Indoor Speaker Strobe Detail

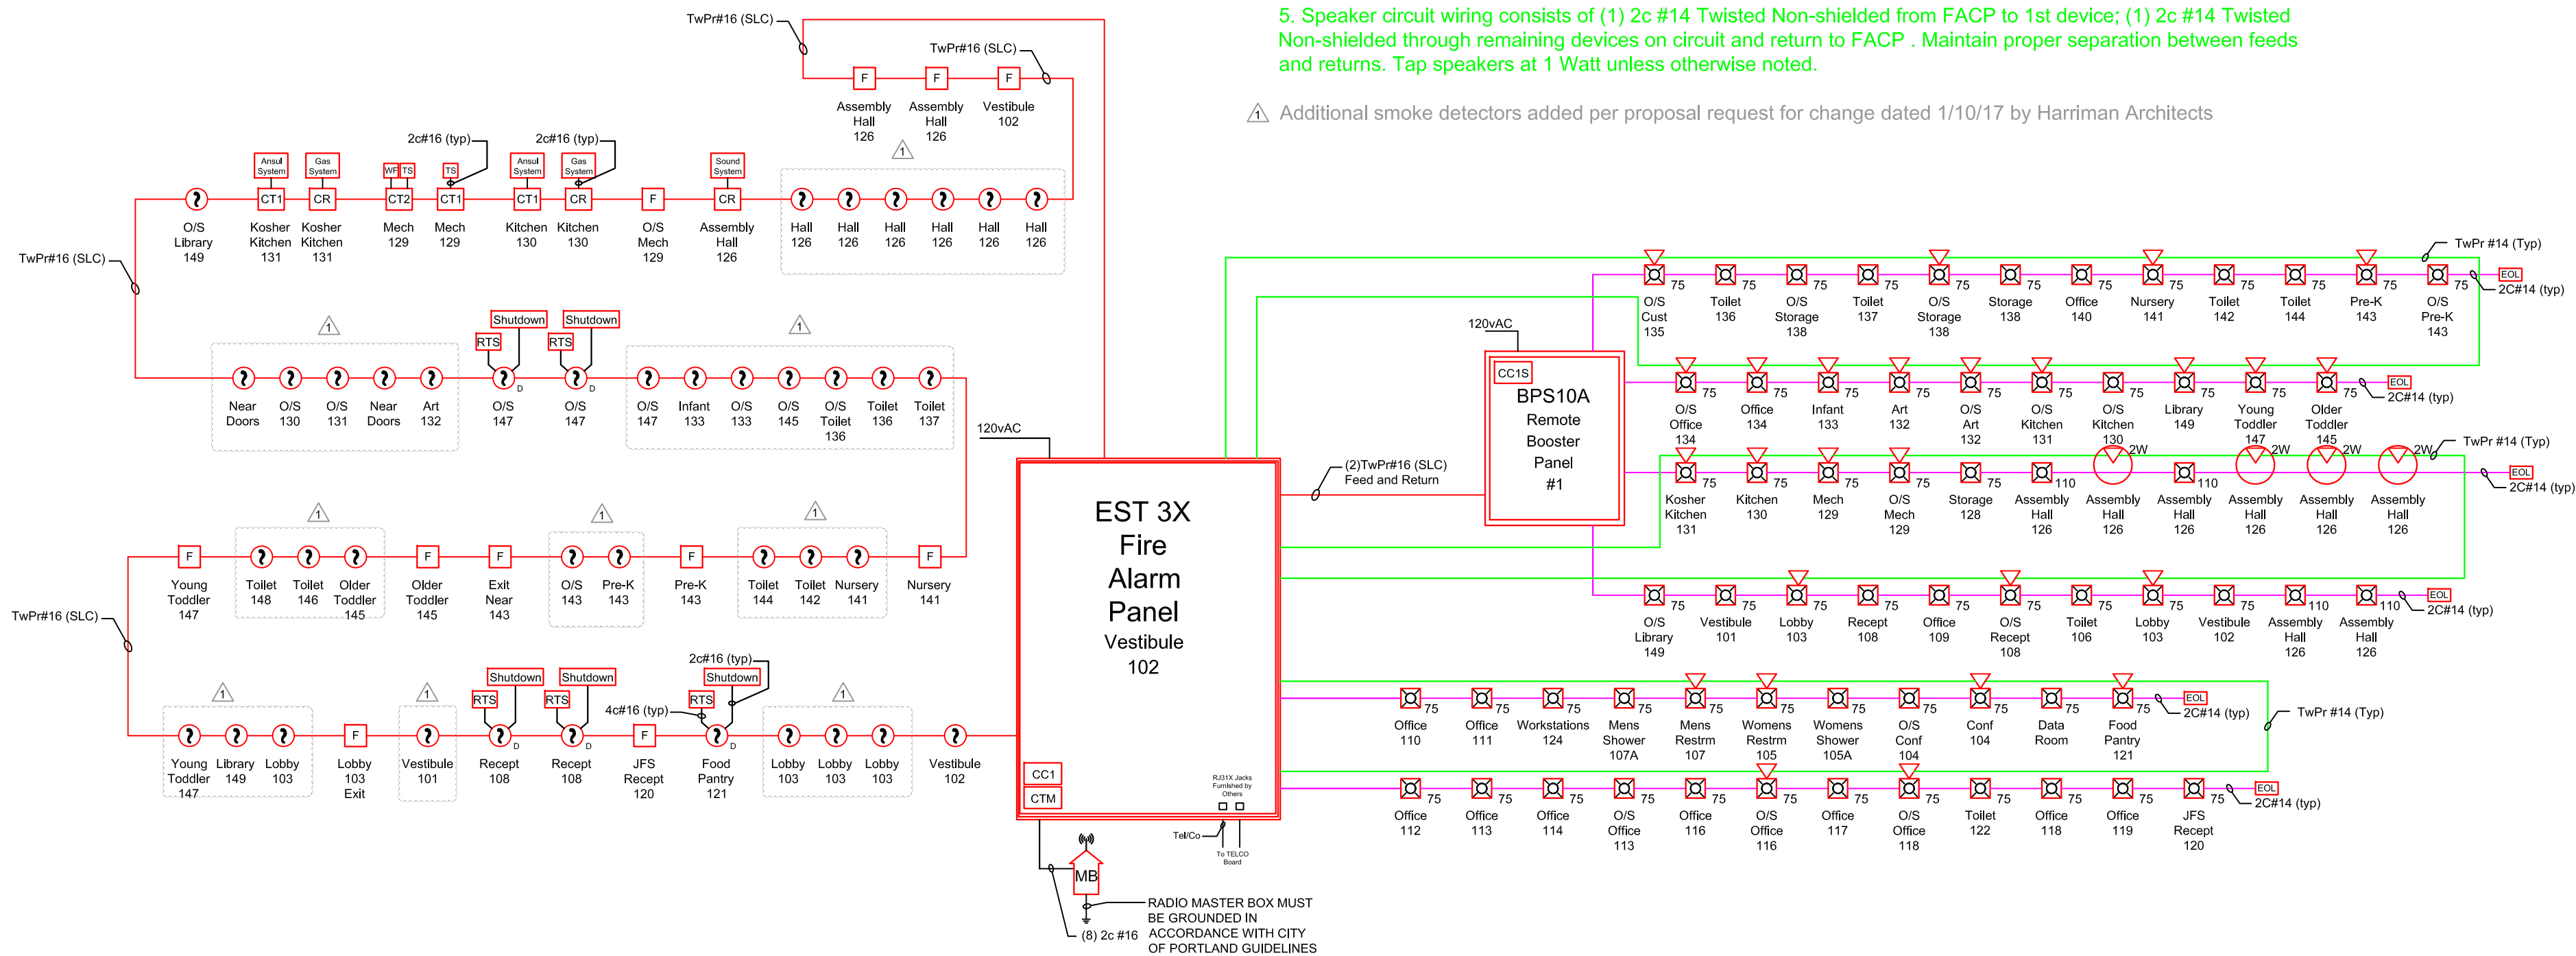
⚠ Additional smoke detectors added per proposal request for change dated 1/10/17 by Harriman Architects

| SCALE: | NTS | TRD | TRD | TRD | DATE | DRWN: | IR/W/D: |
|--------|---------------------------------------------------|---------|-----|-----|------|-------|---------|
| 2 | Address Correction | 2/22/17 | KMB | TRD | | | |
| 1 | Revision based upon added detection dated 1/10/17 | 1/30/17 | KMB | TRD | | | |
